Mr. Bart McDonough, Town Planner Town of Kittery, Maine 200 Rogers Road Kittery, Maine 03904 December 2nd, 2021 Project No. C206-21

RE: Site Plan Review Application – Review Memo Revisions Terra Cotta Pasta Company (Tax Map 3, Lot 1) 52 State Road, Kittery, Maine

- ROADS & DRIVEWAYS TO BE CONSTRUCTED IN ACCORDANCE WITH THE APPROPRIATE CROSS SECTION DETAIL. GRAVEL FILL TO BE COMPACTED TO 95% MODIFIED PROCTOR IN ACCORDANCE WITH ASTM D 1557. LIFT THICKNESSES TO BE A MAXIMUM OF 6".

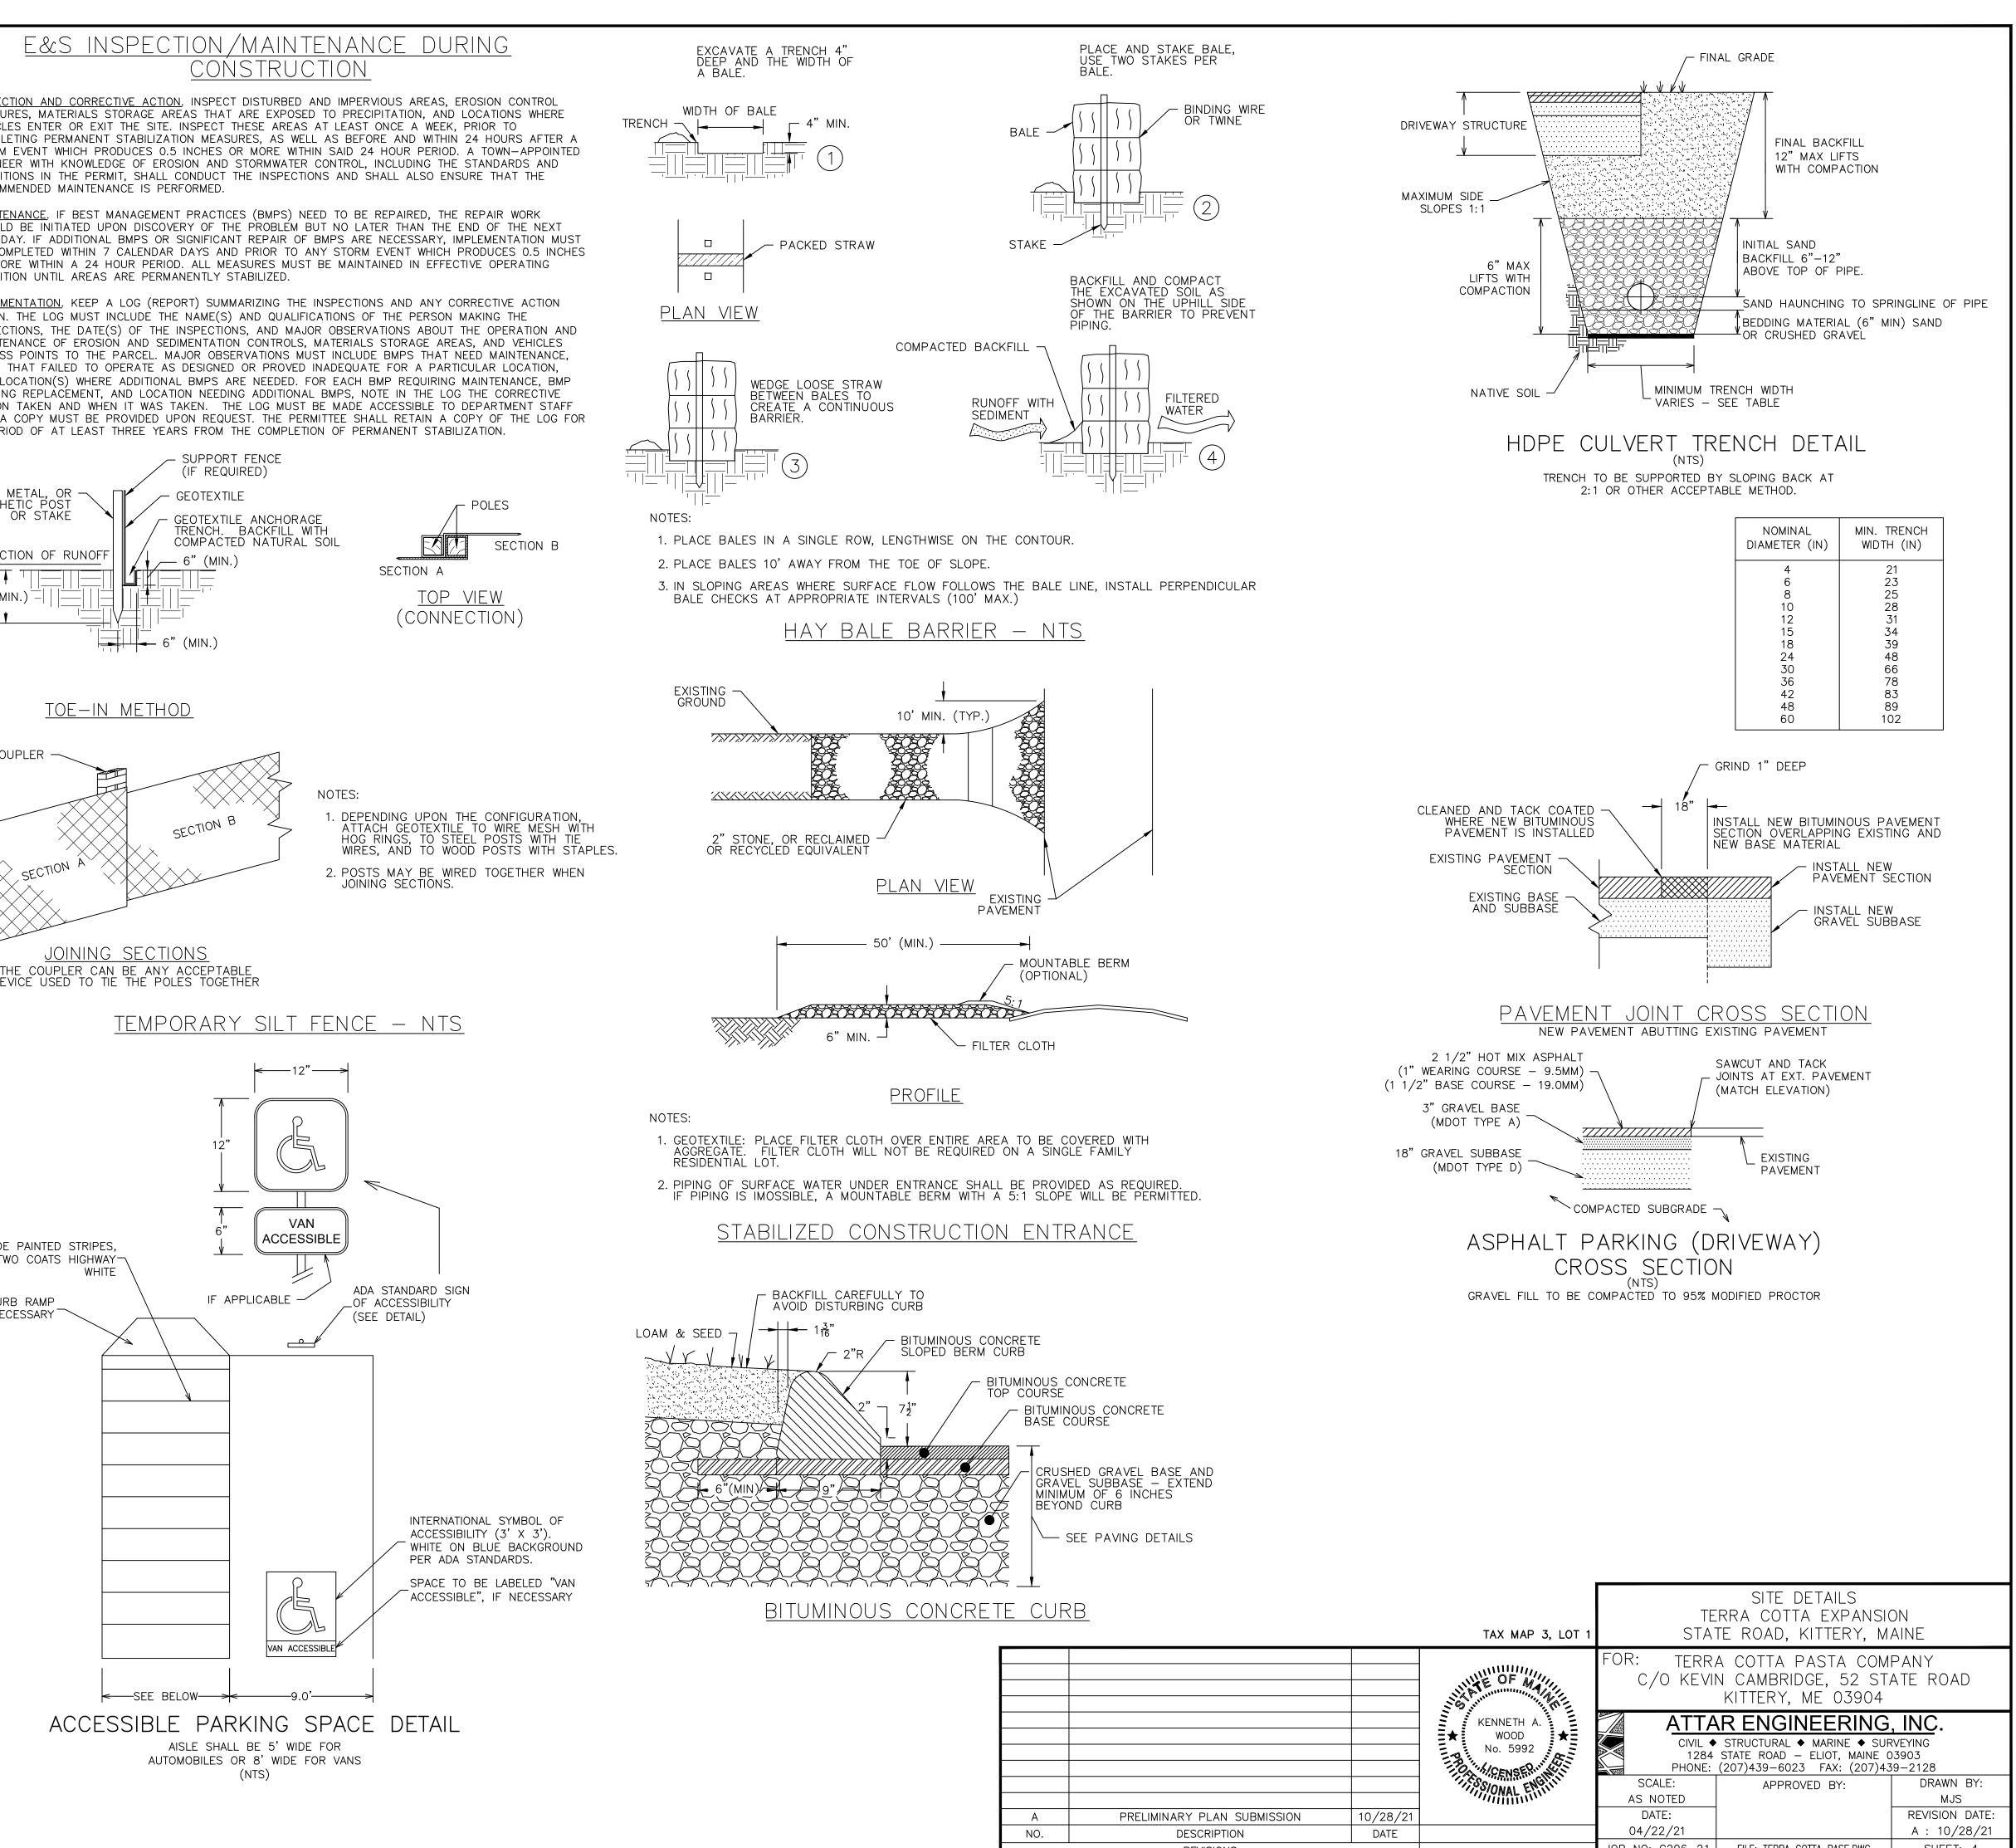
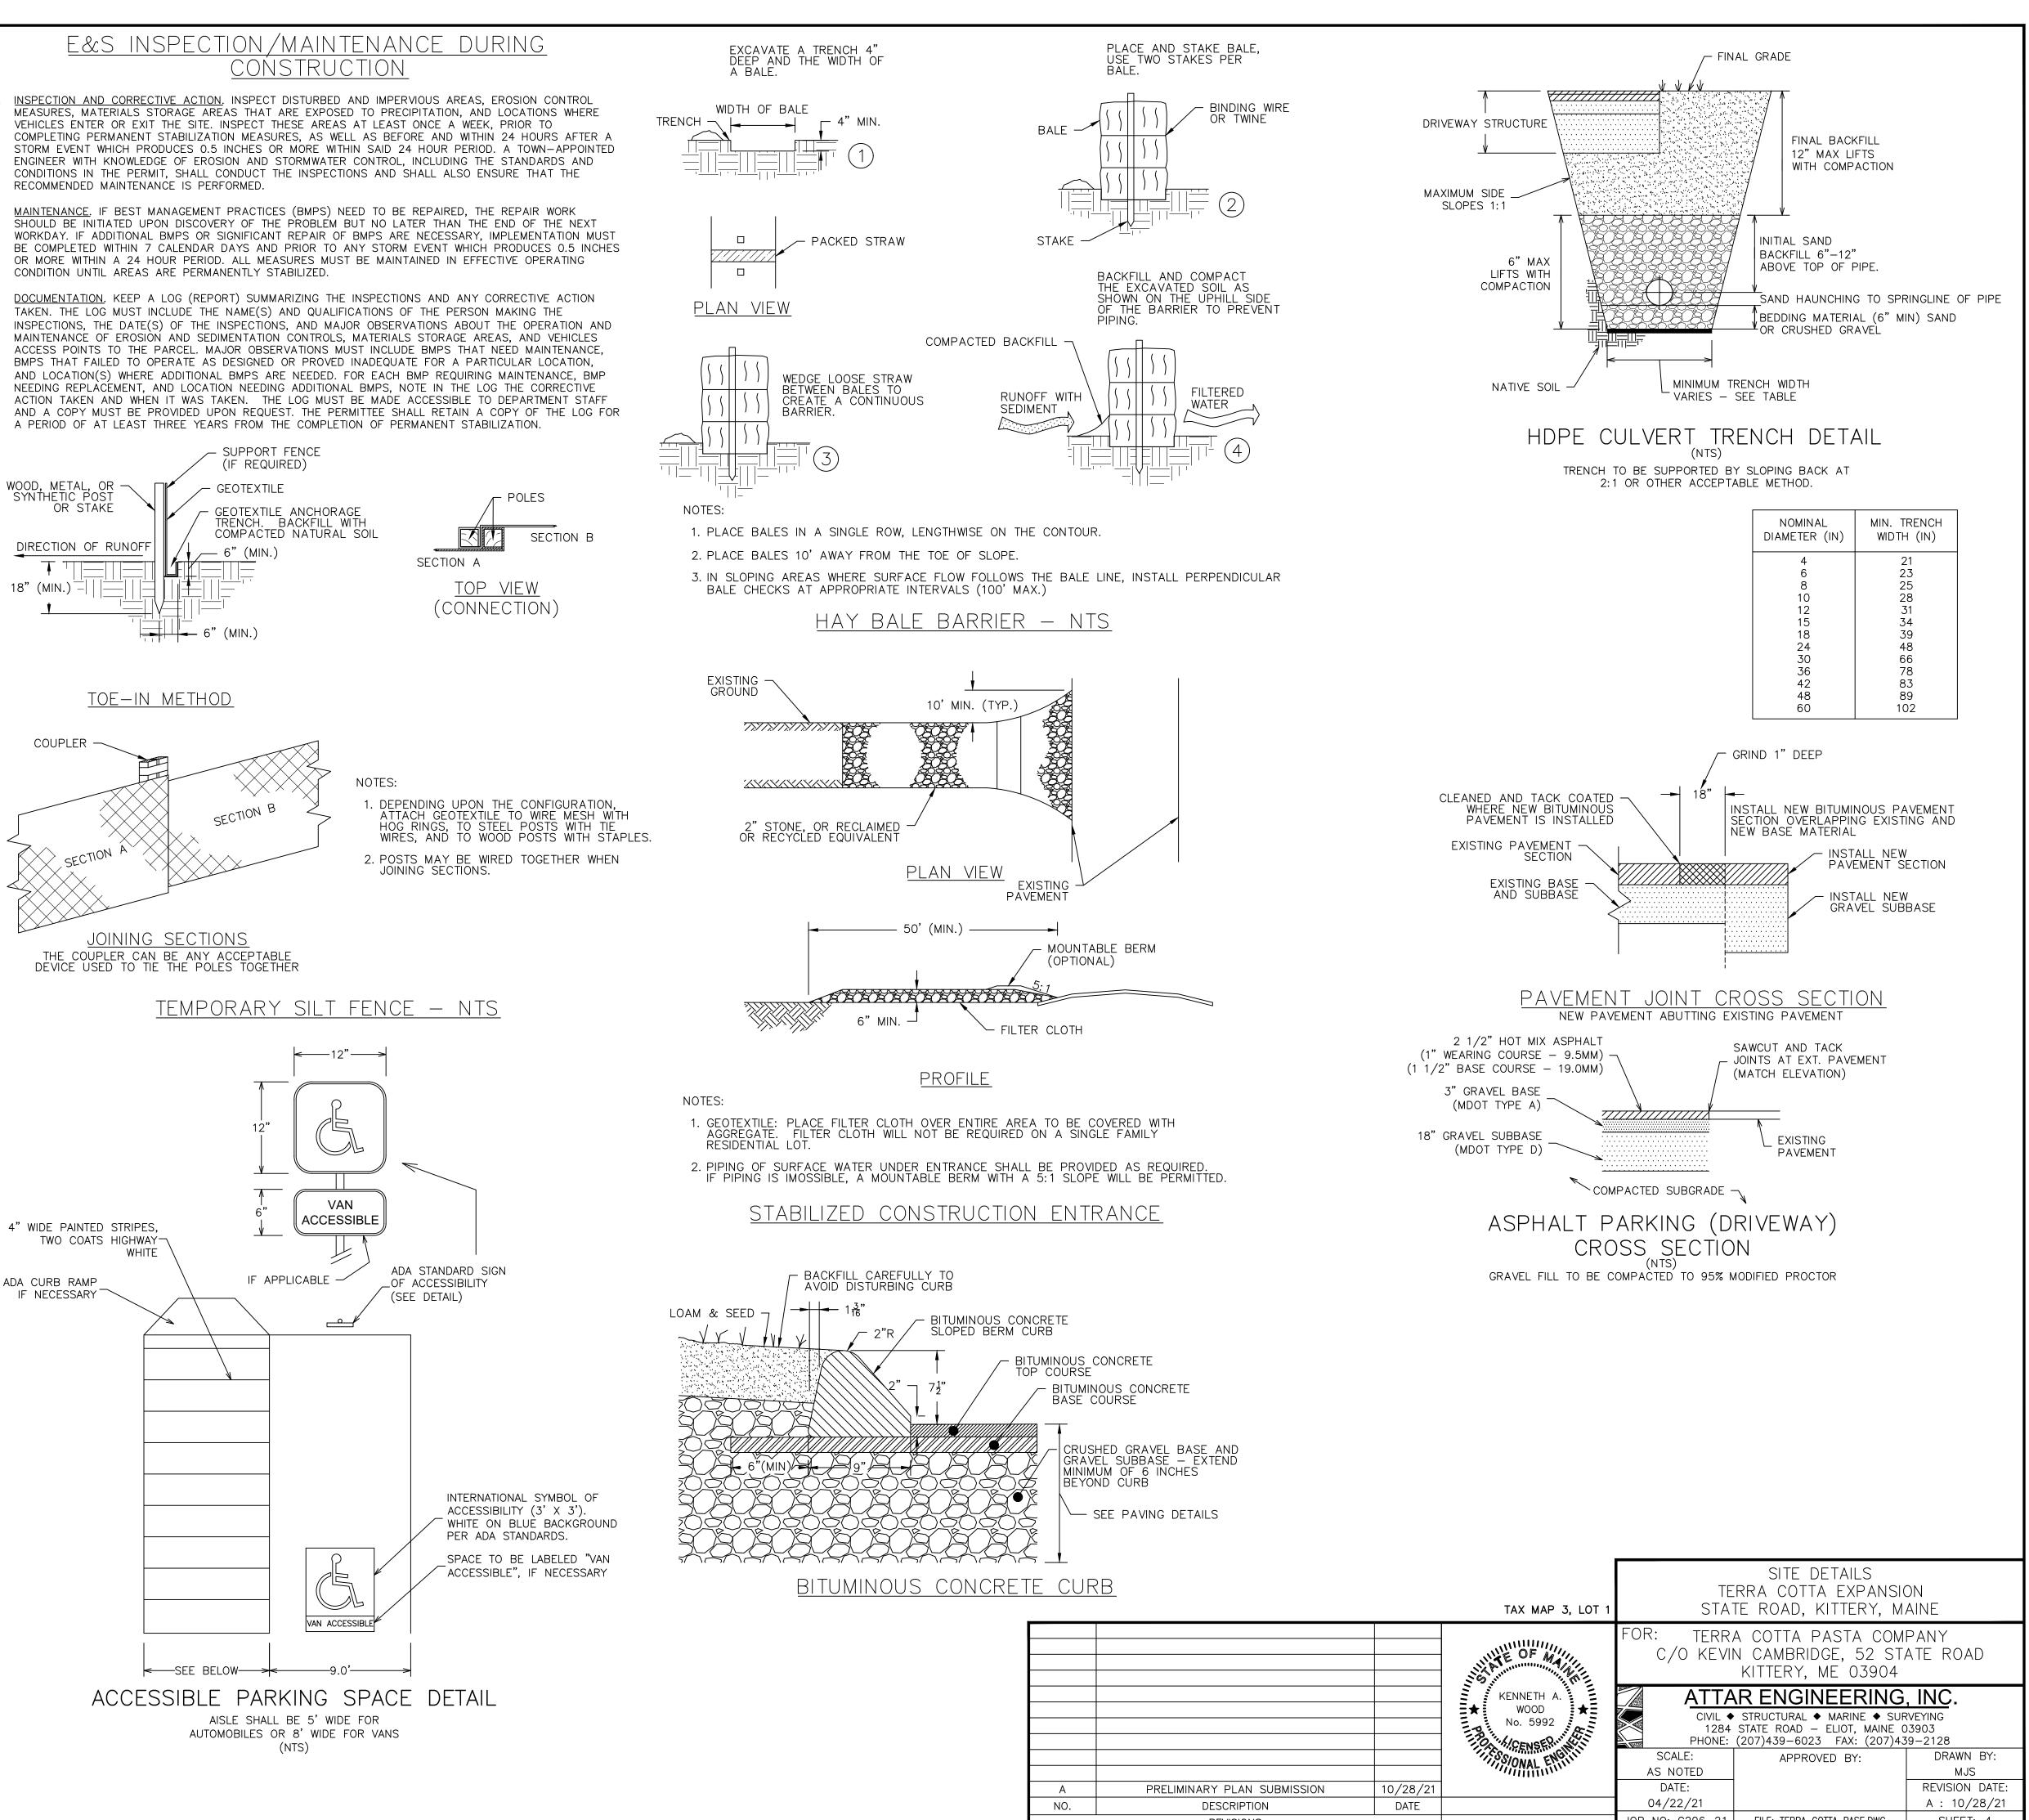
- Sheet 3 (Grading & Utility Plan) has been revised to include a solid-shade hatch to designate areas that are to be dedicated to landscaping in the developed condition. General Note #4 on Sheet 3 has been added to demonstrate compliance with §16.3.2.9.D(1)(i) and §16.3.2.9.D(4)(a).

- Sheet 3 has been revised to include a species-specific planting list for the proposed trees and shrubs to be located alongside the rear parking lot, as per §16.3.2.9.D(4)(e).

- Sheet 3 has been revised to depict snow storage locations around the parking lot and rear loading area. General Note #5 on Sheet 3 has been added with the suggested language for excess snow being carried off-site.

| | | TAX MAP 3, LOT 1 | | PHOTOMETRIC PLAN RRA COTTA EXPANSION TE ROAD, KITTERY, M | |

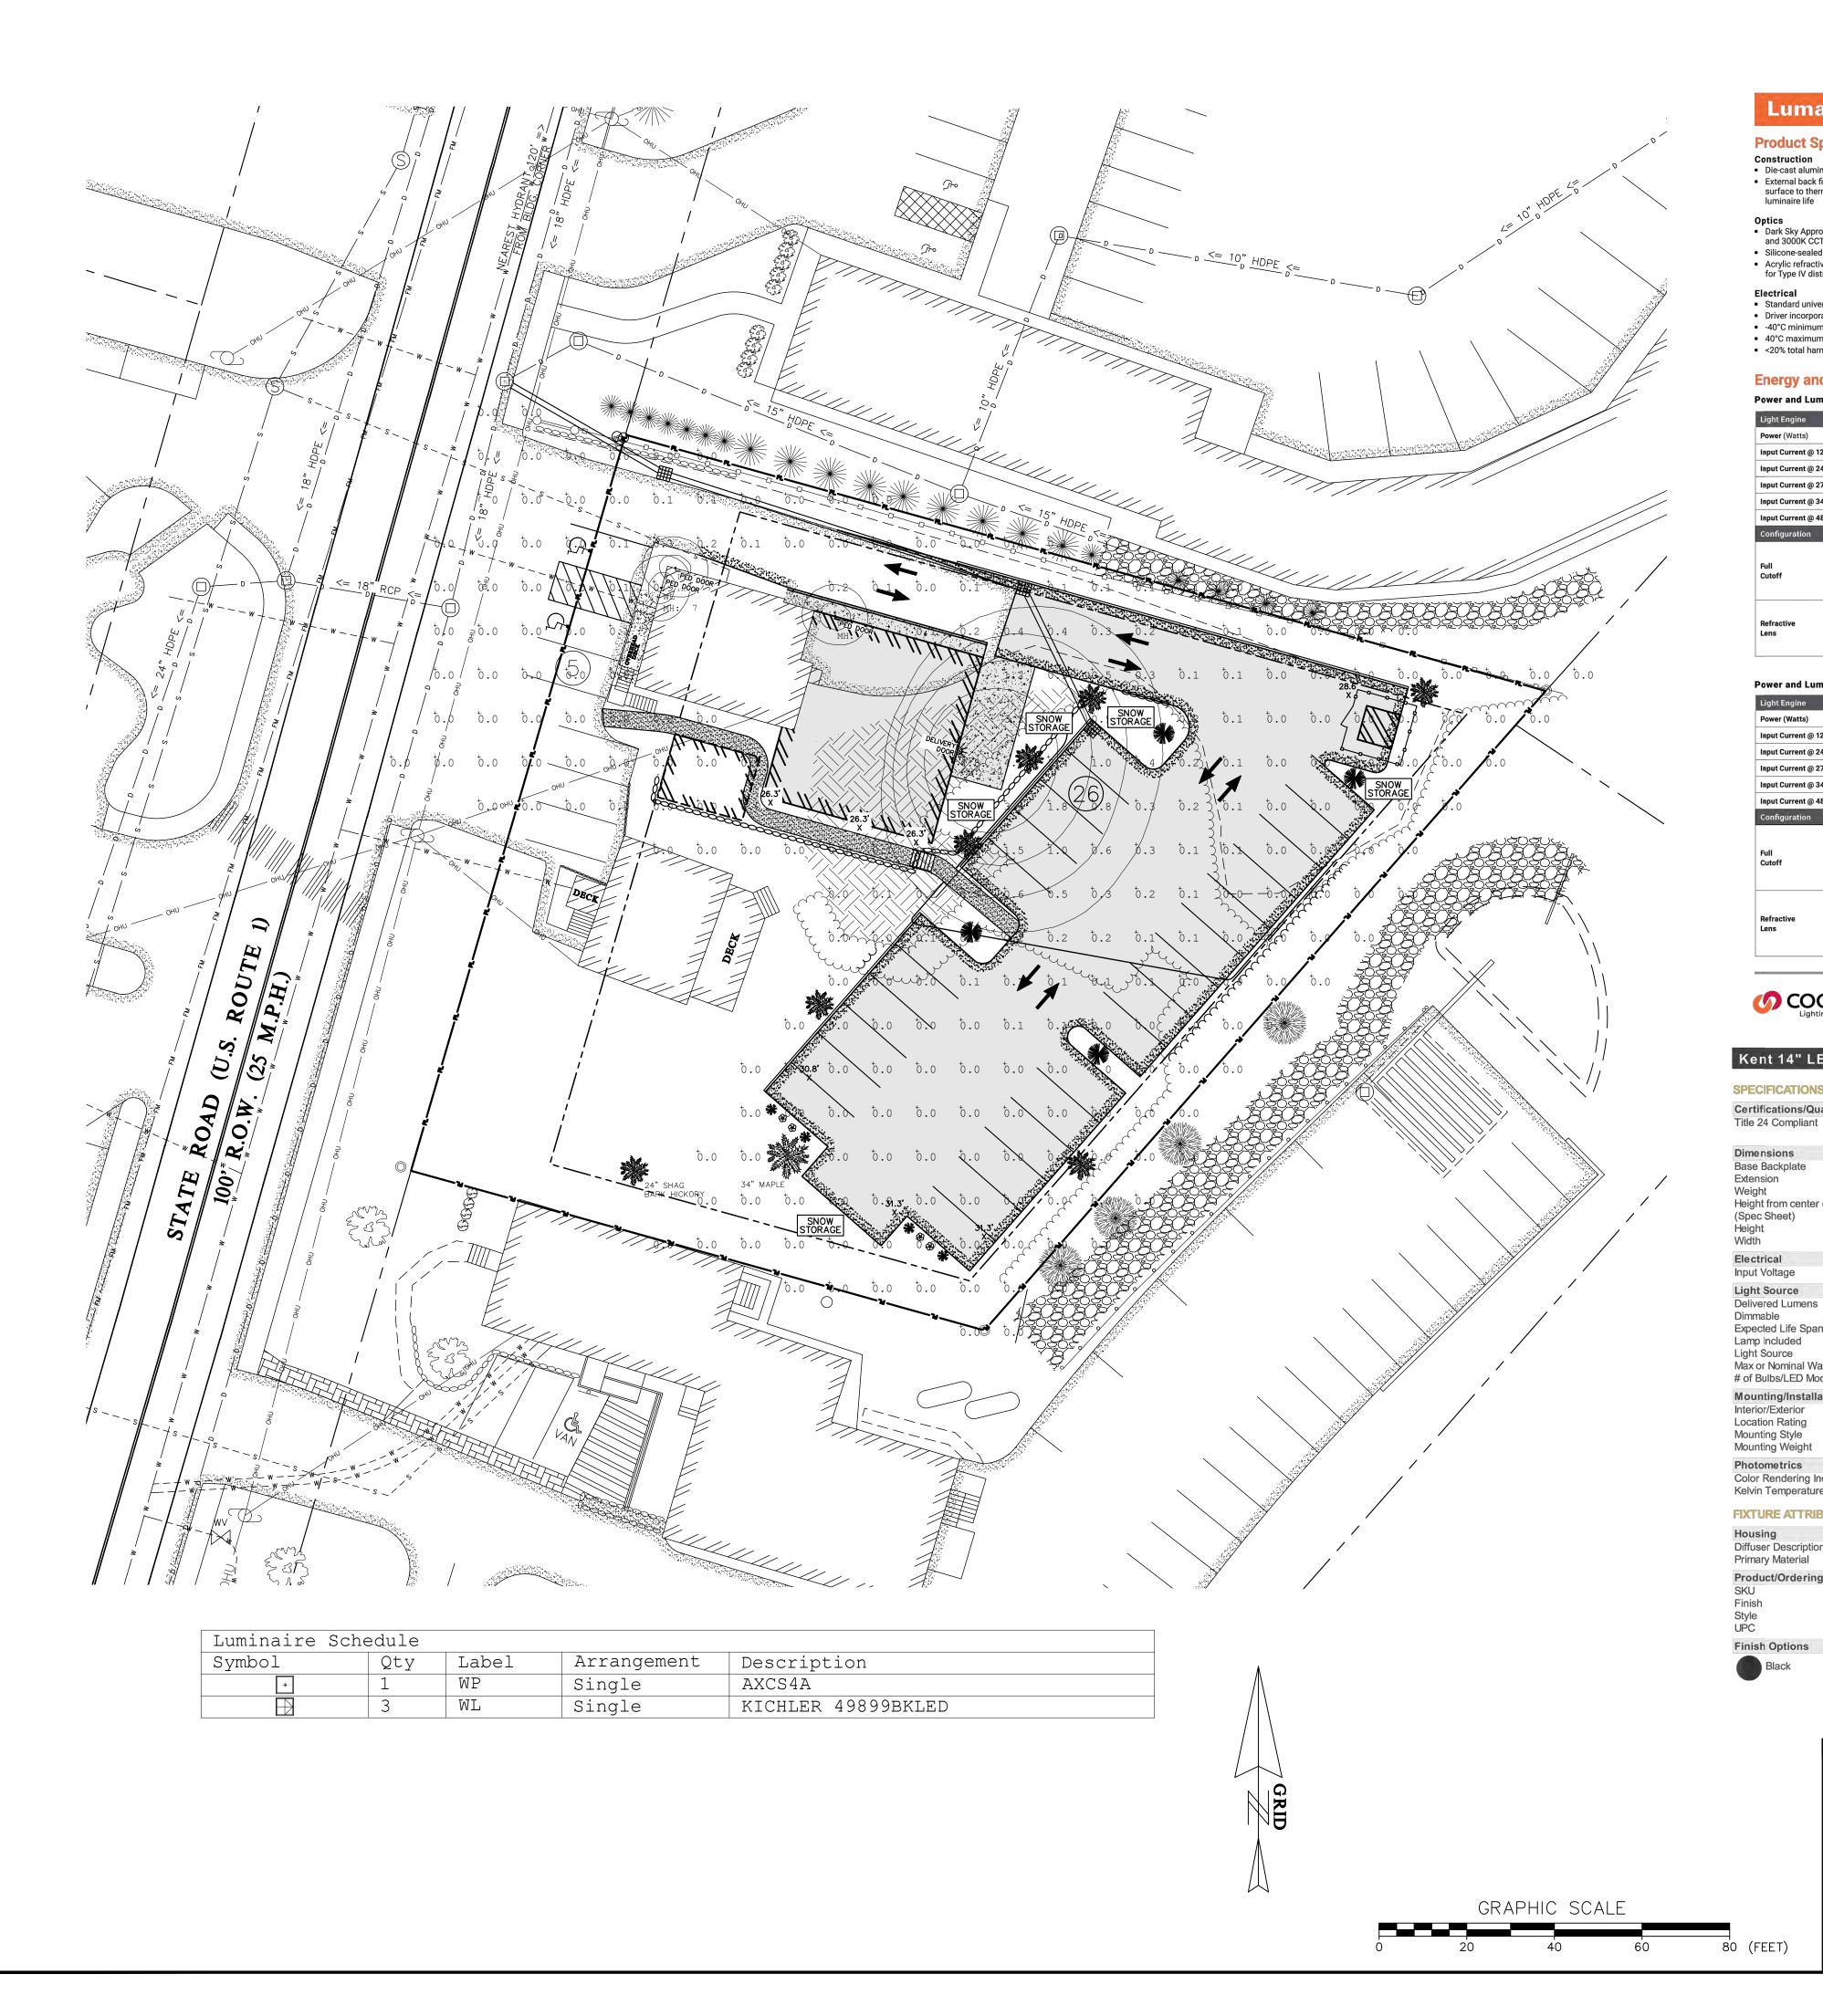
- A proposed Photometric Plan has been added to the plan set to depict lighting in the developed condition. Existing lighting on the front of the building and by the pedestrian entrances is not proposed to change, with the one lighting addition being a forward-throw wall pack on the rear of the proposed addition, facing the parking lot. Specification sheets for all lighting are also attached.
- An updated deed proving adequate right, title, and interest is attached.
- Sheet 3 has been attached to depict the approximate location of the existing water and sewer utility service connections.
